To: Development Determination Panel
Cc: Adam Richardson
From: Luke Zajac (Consultant Planner - Mecone)
Date: 16 January 2023
Subject: Supplementary Assessment Report
Record Number: DA2022/0742

SUPPLEMENTARY ASSESSMENT REPORT

Figure 1: Comparison of original (red) and amended (yellow) schemes – south elevation.

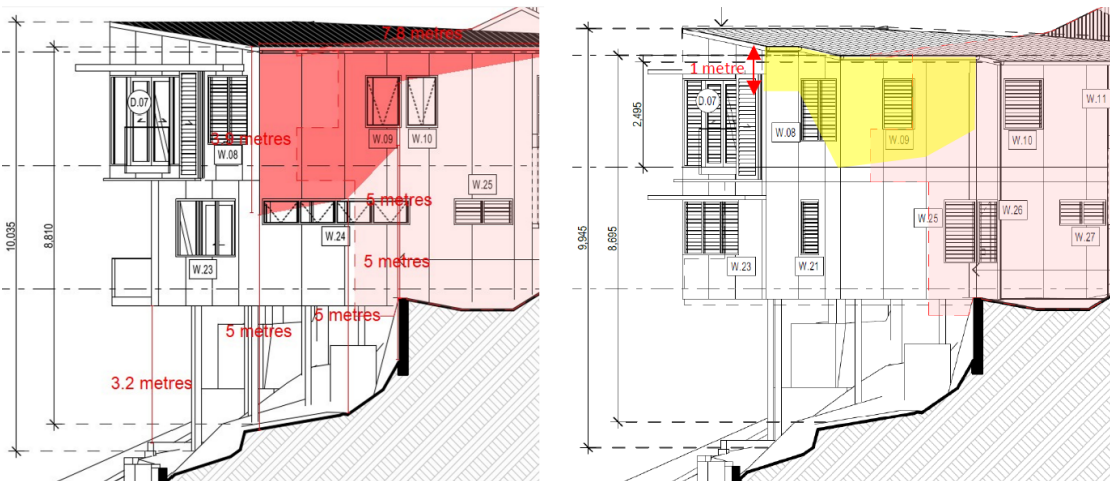
Part D1.11 of the PDCP 21 requires a building envelope of 3.5 metres plus the setback of a flank elevation to the correlating boundary. The proposed alterations and additions provide the following building envelope non-compliances:

- Southern setback: Encroachment of 0 metres to 2.5 metres for a length of 7.8 metres (up to 41.6% variation)
- Northern setback: Encroachment of 0 metres to 1.8 metres for a length of 2.7 metres (up to 51.4% variation)

Amended plans were submitted by the applicant, in which the side setback at the southwestern corner was increased from 1.5m to 2.6m. This has reduced the extent of the building envelope variation in this location, from 3.9m to 1m.

A diagram of the approximate encroachments is below:

It is recognised that clause D1.11 of P21 DCP provides an expressed variation for steeply sloping sites where the dwelling is located on a slope in excess of 30%. The application of this variation is considered acceptable in the circumstances of this application, as the building is situated on a slope in excess of 30% and achieves the outcomes of the control:

The proposed encroachments into the building envelope are deemed acceptable on the basis of the design's response to site constraints including its steep slope and the siting of the existing dwelling close to the site frontage, at the narrower portion of the irregular shaped lot. Due to the slope of the site from Chisholm Ave, the alterations and additions, including the breaching elements, will largely be hidden from the public domain. The amended design reduces the variation at the point of greatest impact to the adjoining dwelling, the south-western corner. The alterations will not result in adverse privacy, bulk and scale, overshadowing or view loss impacts to the adjoining dwellings at 76 and 80 Chisholm Ave. In doing so, the proposal will continue to provide for a low density residential area with dwelling houses of two storeys located in a landscaped setting, a achieving the desired character of the Avalon Beach Locality, pursuant to clause A4.1 of the PDCP 21.
